# UNITED STATES PATENT AND TRADEMARK OFFICE

APPLICATION NO.	FILING DATE	FIRST NAMED INVENTOR	ATTORNEY DOCKET NO.	CONFIRMATION NO.
10/723,767	11/26/2003	Koji Yanagihara	16UL03229	9684

**Office Action Summary**

(Source: Van Creveld (US Pat. No. 5,810,733) Figures 3 and 4)

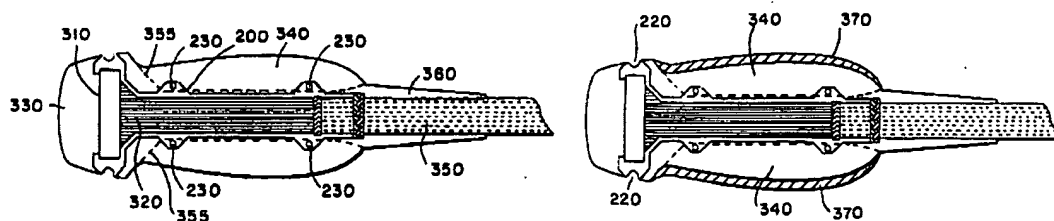
Regarding claim 1, Van Creveld ('733) discloses an ultrasonic probe having a transceiver unit and an enclosure housing for the unit, including a first partial enclosure **370** formed of hard plastics having an opening at the tip, and a second partial enclosure **330** integrally formed with the first partial enclosure (Figs. 3 & 4). Van Creveld ('733) discloses that the second partial enclosure is made of a soft flexible material in order to minimize patient discomfort during imaging (col. 6 lines 23-25).
